# Modification of Minister's Approval

## Section 75W of the *Environmental Planning and Assessment Act 1979*

Concept Approval (MP 06\_0225), granted by the former Minister for Planning on 3 June 2010 for the development of an Asphalt and Concrete Production and Recycling Facility, subdivision and associated infrastructure works at Lot 5 in DP 1145808 in the Blacktown local government area.

## HANSON SITE HANSON LAND, EASTERN CREEK

**APPENDIX 1: Modified Concept Plan**

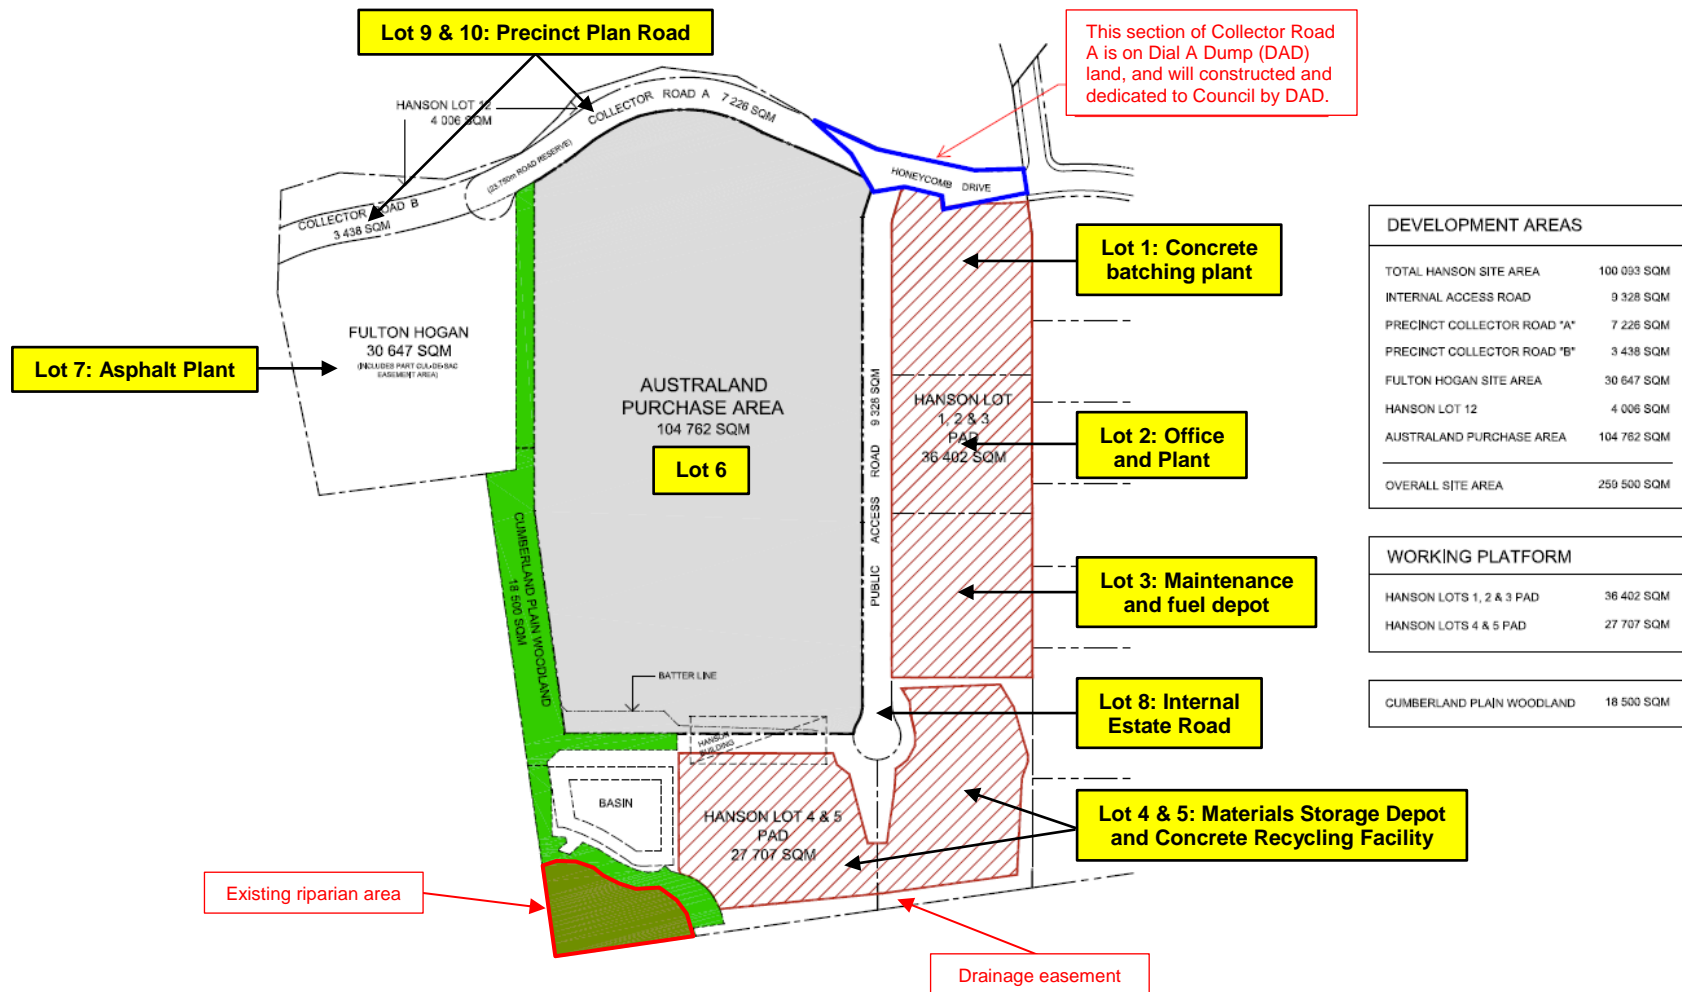
5. Delete Appendix 1 and replace with the following:
